# 45 McLaren St

## North Sydney

Response to Council RFI

February 2024

Lower Ground

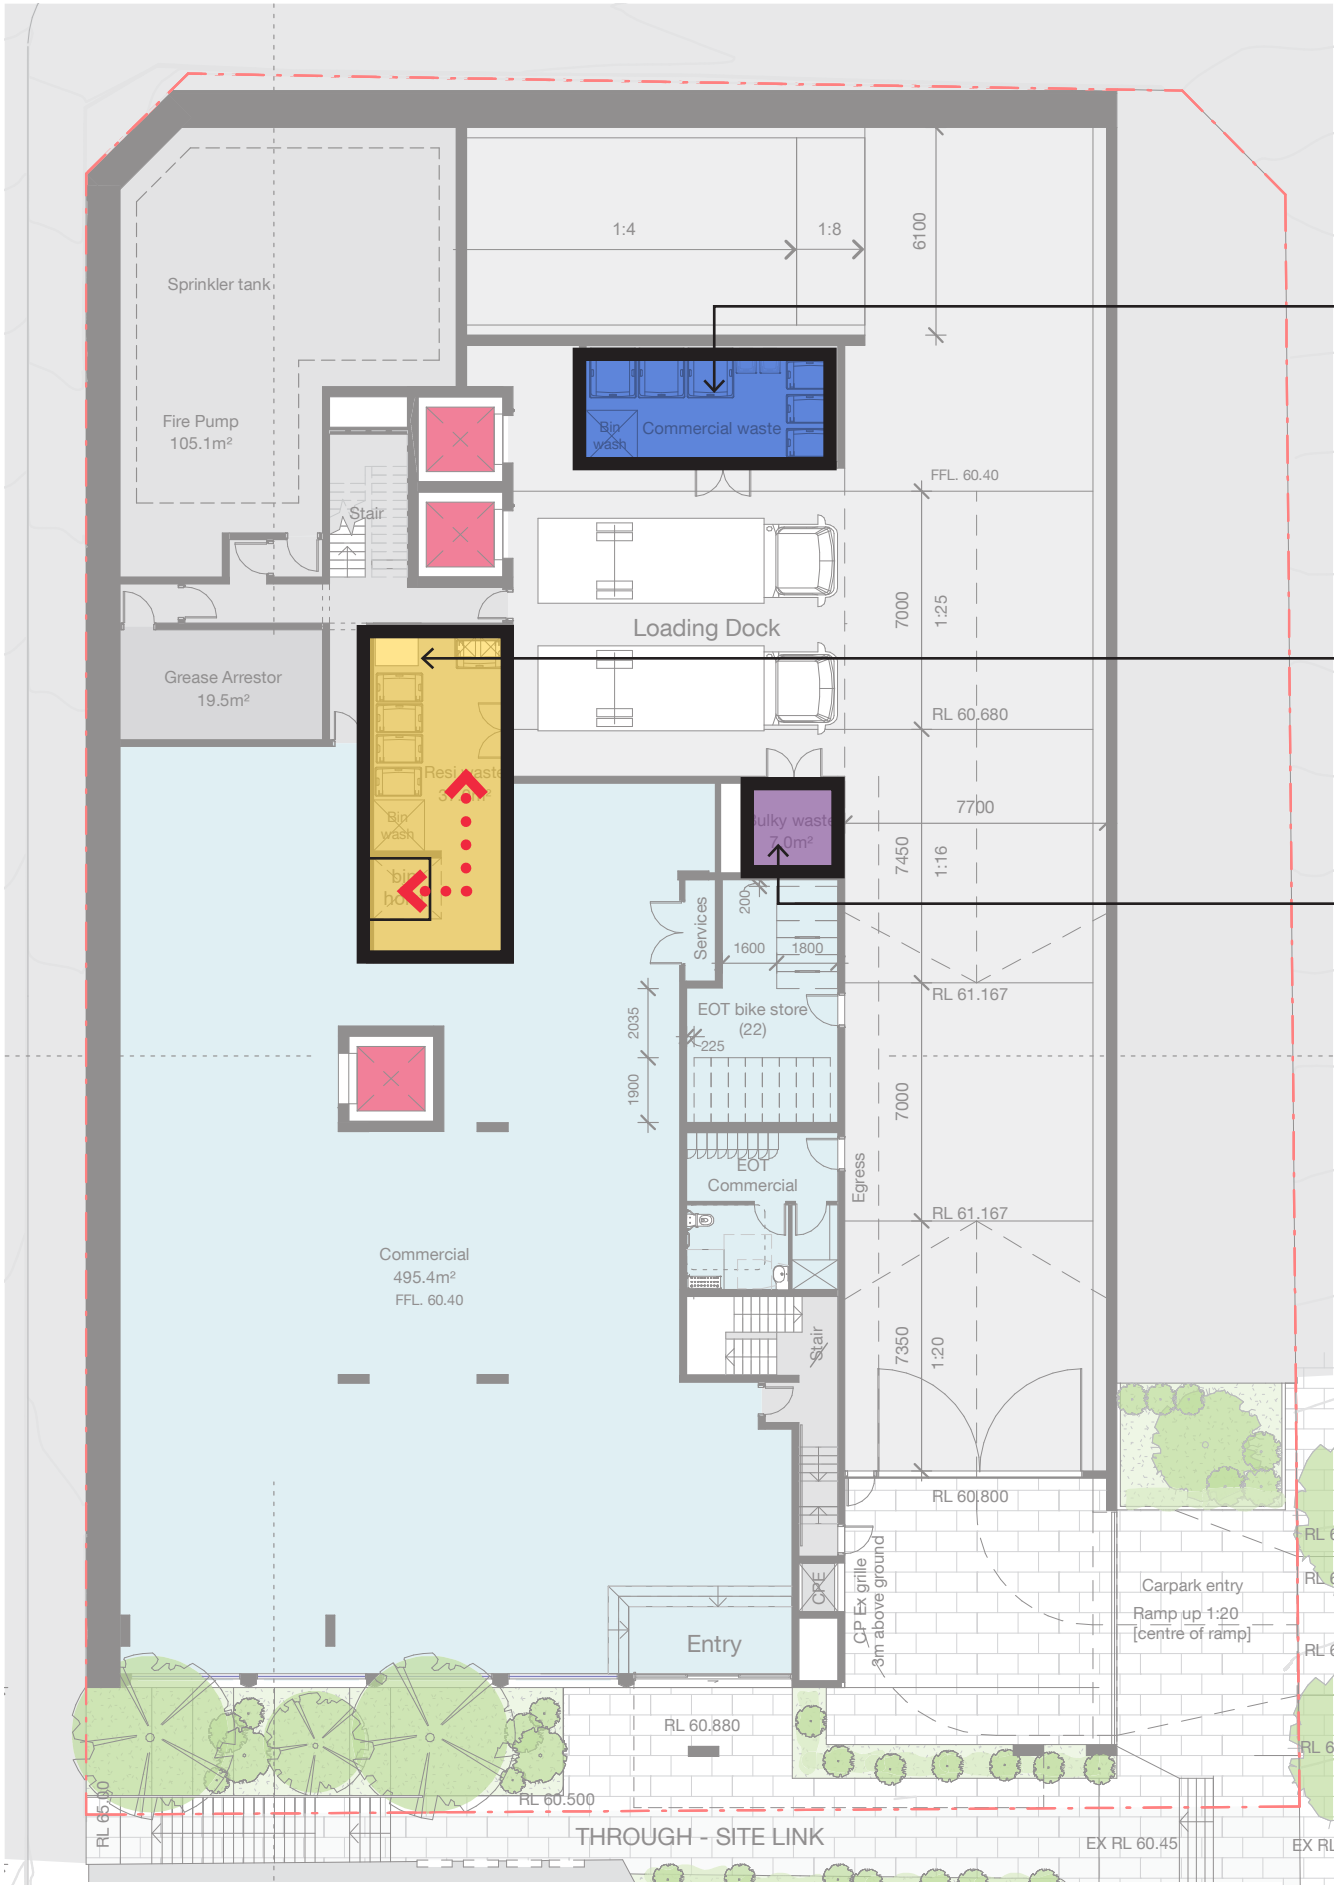
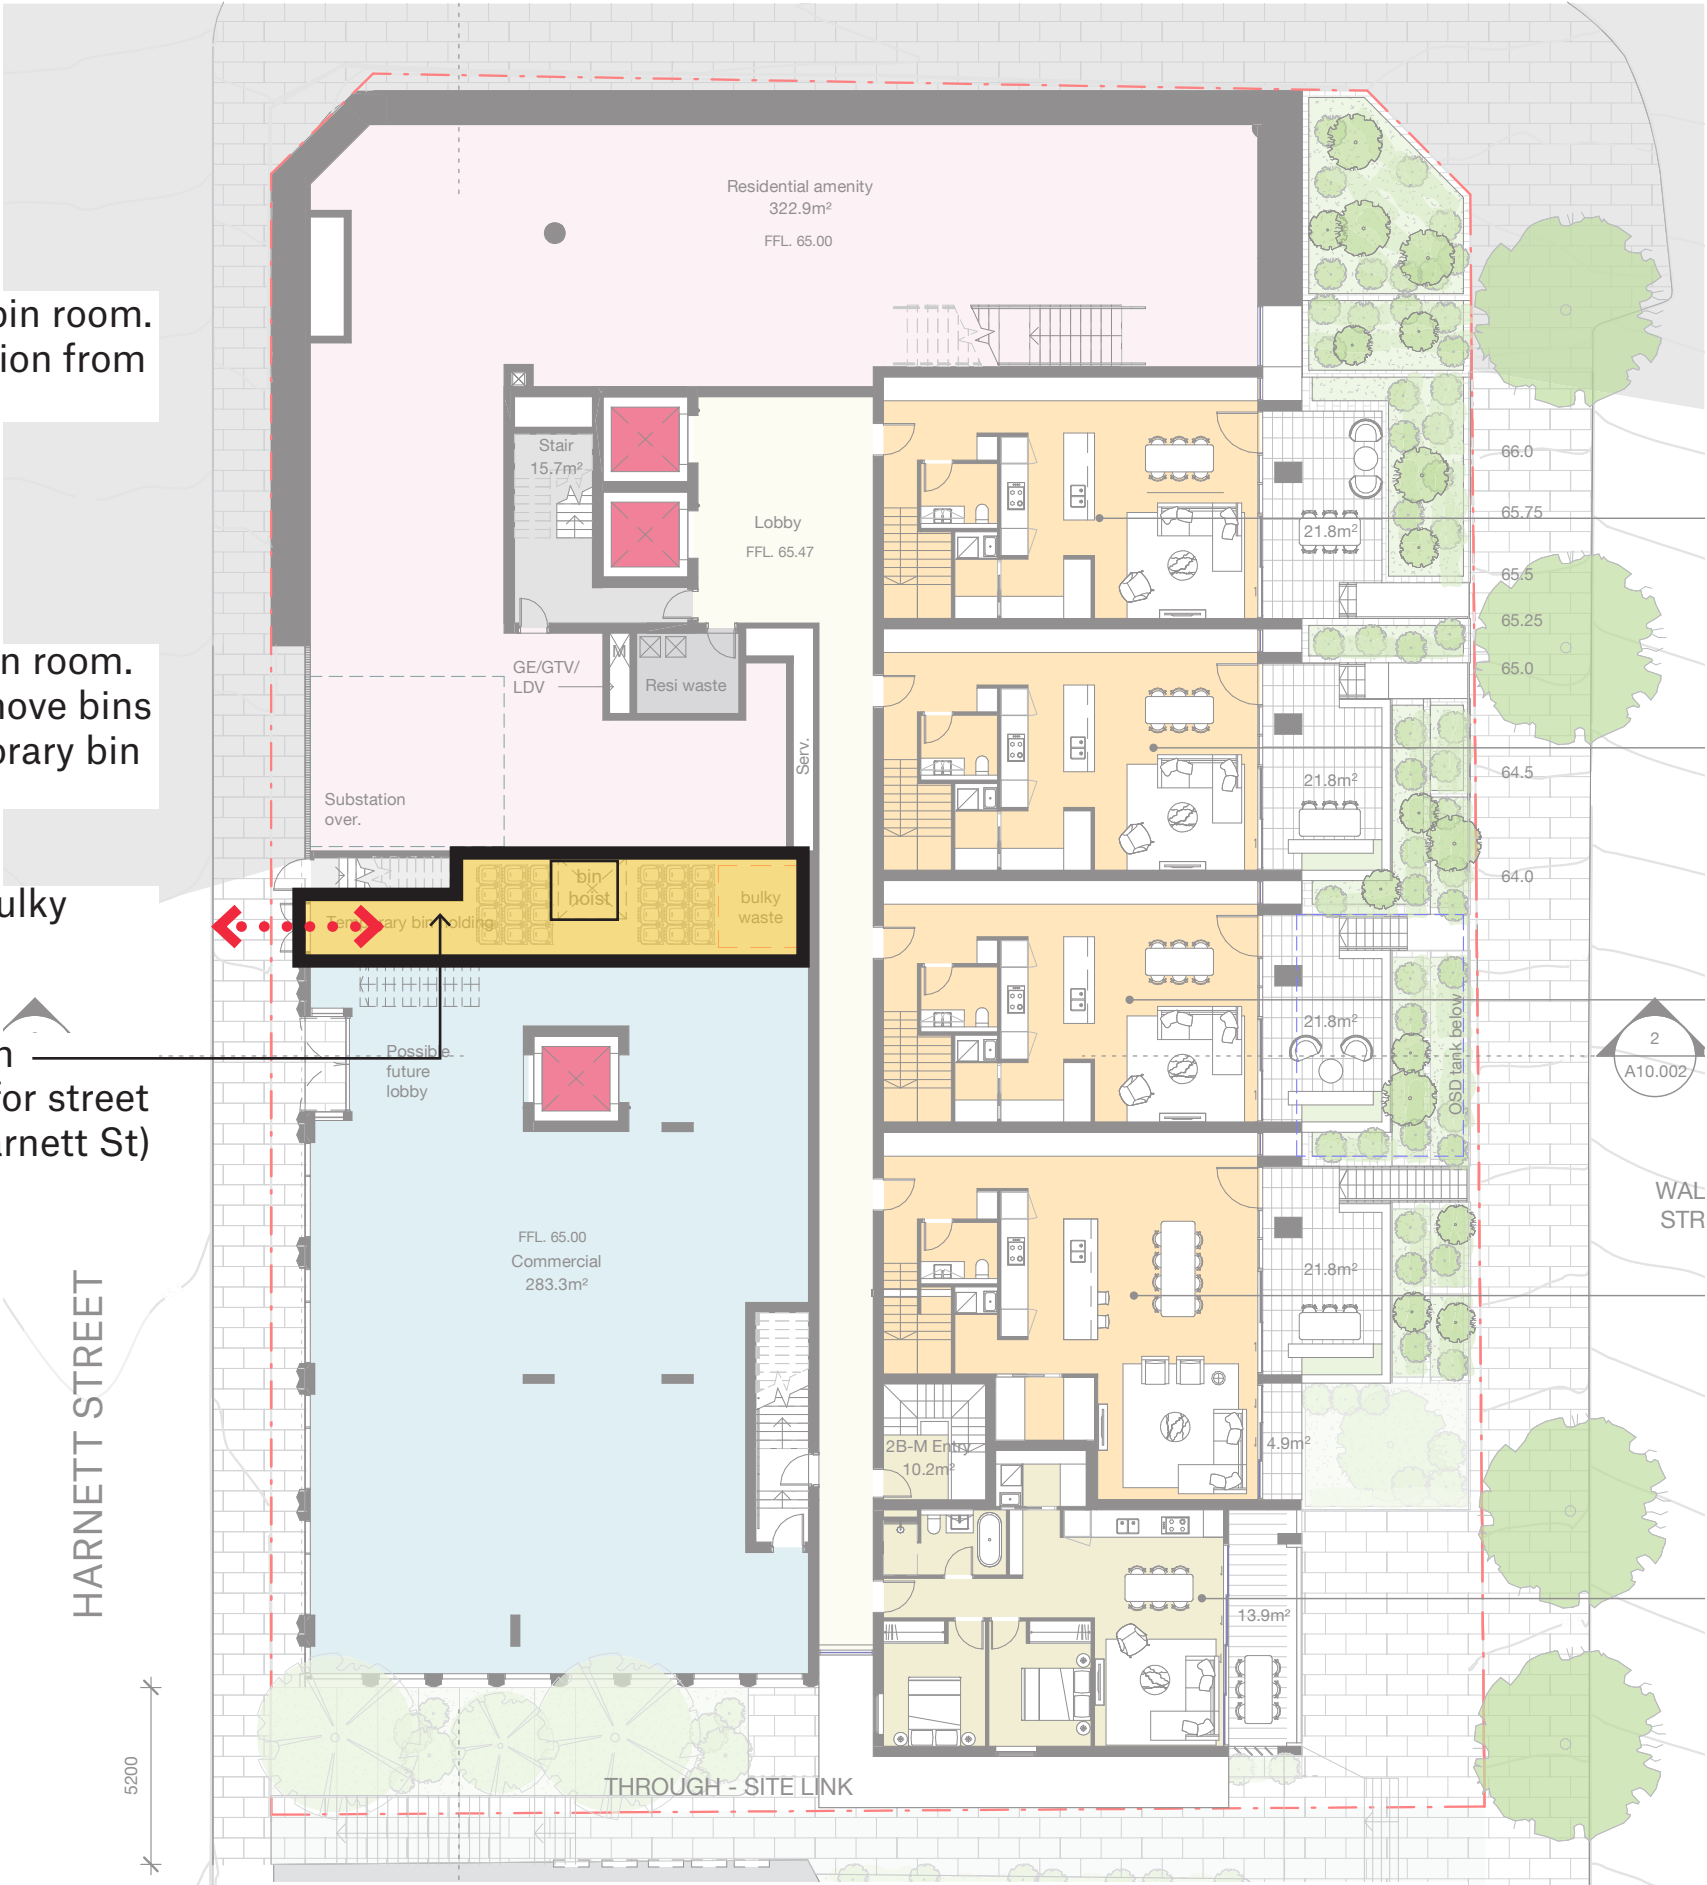
*The **residential waste bins** need a **temporary bin holding area for collection from the street** within 2 metres of the property boundary. The holding bay must be large enough to fit 24 x 240L bins (compacted waste) and bulky waste material and be consistent with NSDCP 2013 Appendix 3 – Waste Management Guide, for high-rise, residential and mixed residential/commercial buildings.*

*Onsite collection for residential premises is not permitted, the **bin holding bay must be accessible from the kerb**.*

*However, **commercial bins** must not be presented kerbside and **must have a bin holding bay for collection on-site**.*

The following plans highlight the path of travel for bins from loading dock to temporary bin holding area for residential waste on Harnett Street. As noted in council RFI, a designated bulky waste room has been proposed in the loading dock.

The commercial waste is proposed to be collected from loading dock on site.
